In the Matter of  
FLORIDA POWER AND LIGHT COMPANY  
(Turkey Point Plant, Unit Nos. 3 and 4)  
Docket Nos. 50-250, 50-251 OLA  
(SFP Amendment)

The Commission has issued the enclosed Amendment No. 111 to Facility Operating License No. DPR-31 and Amendment No. 105 to Facility Operating License No. DPR-41 for the Turkey Point Plant Units Nos. 3 and 4, respectively. The amendments consist of changes to the Technical Specifications in response to your application transmitted by letter dated March 14, 1983, as supplemented.

These amendments allow spent fuel pool storage capacity expansion from 621 to 1404 spaces for each spent fuel pool. The expansion is to be achieved by reracking each spent fuel pool with two discrete regions within each pool. Region I is for storage of new fuel with an enrichment equal to or less than 4.5% U-235. Region II is for storage of irradiate fuel meeting the burnup requirements defined in the Technical Specifications.

Our evaluation of the structural aspects of the proposed modifications are based on a review performed by the staff's consultant, Franklin Research Center (FRC). The FRC Technical Evaluation Report, TER-C5506-529, is appended

Figure 3. Two-Dimensional Nonlinear Model

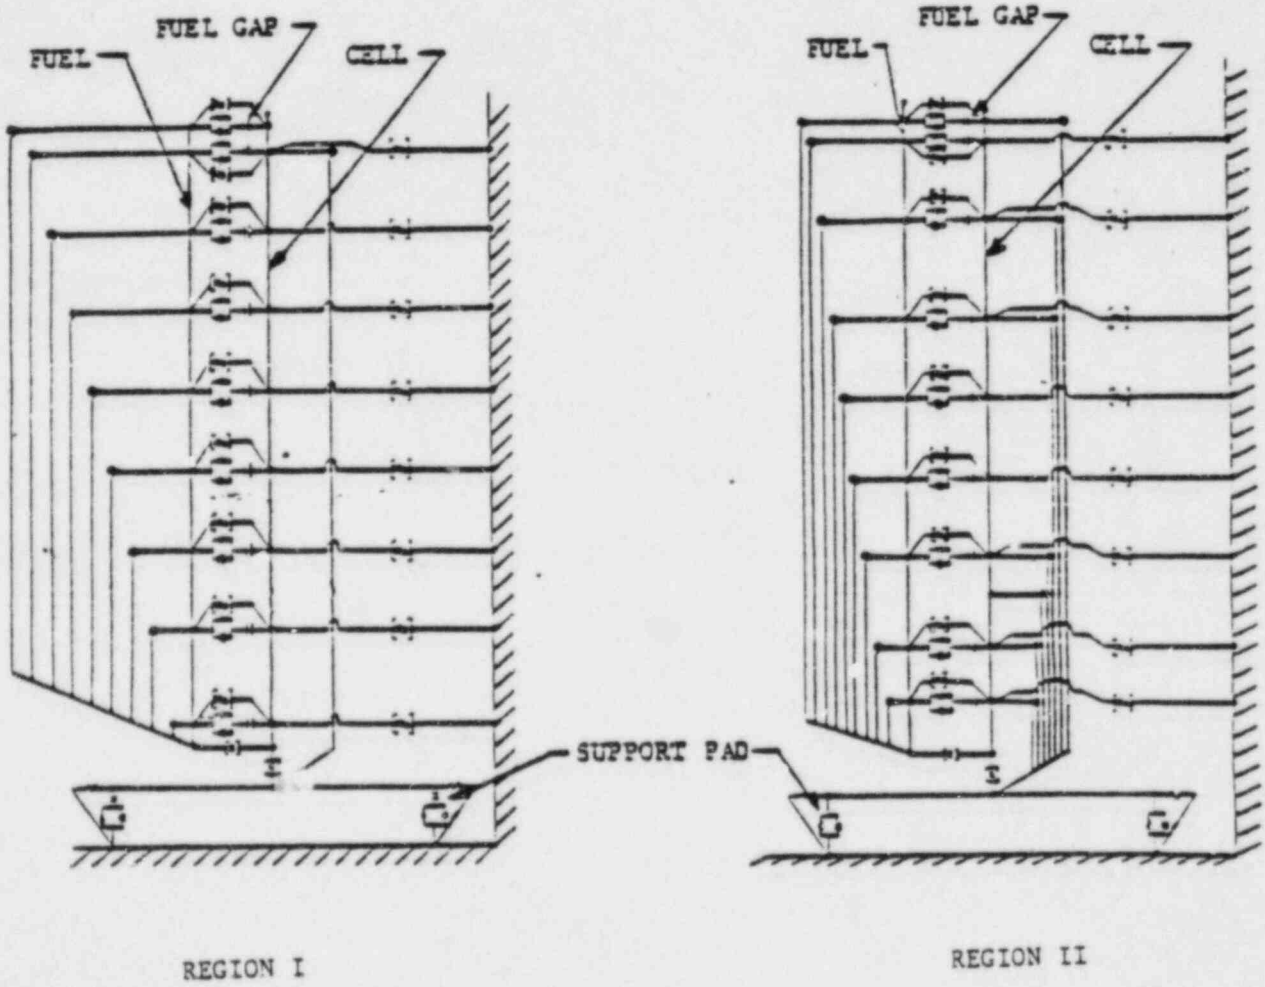
The assumption in Item d may be valid when adjacent modules are fully loaded, but the out-of-phase response will most likely occur when some modules are either partially loaded or empty.

mass between the rack module and the pool wall, as shown in Figure 3, was calculated by evaluating the effects of the gap between the modules and the pool wall using the method outlined in the paper by Fritz [6].

The Licensee performed a time step study in an effort to find the correct integration time step to yield a converged solution [5]. It was found that the convergence of solution occurred at a time step of 0.001 sec for modules in Region I and 0.005 sec for modules in Region II [4]. These time steps are much greater than the  $2.0 \times 10^{-4}$  sec reported by Gilmore of Westinghouse in a similar analysis [8]. The Licensee explained that the wide range of time steps that yield convergence may be responsible for these differing values.

Figure 5. Comparison of Mounting Pad Loads for the Nonlinear and Linear Rack Analysis Modules

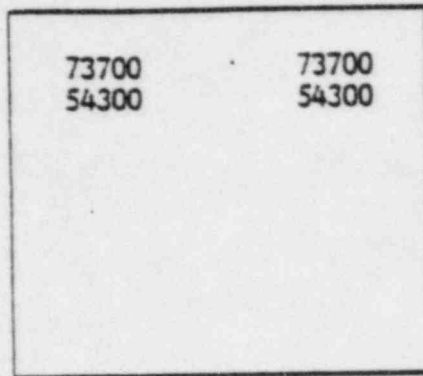
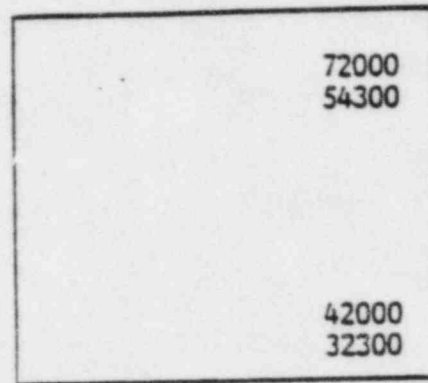
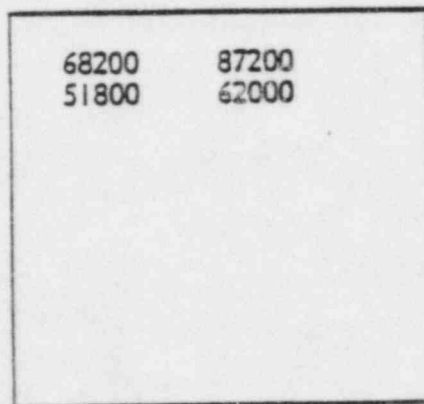
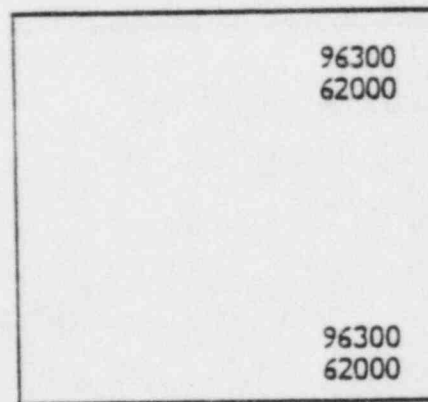
Because load correction factors based on base moment and base shear force were employed by the Licensee to introduce the dynamic response from the nonlinear two-dimensional dynamic displacement analysis model to the linear three-dimensional stress analysis, the Licensee provided a comparison of the vertical mounting pad forces in the linear and nonlinear models. Figure 5, which is taken from the Licensee response [5], shows that the summation of vertical forces in the two analysis models is reasonably close and is considered to be satisfactory.
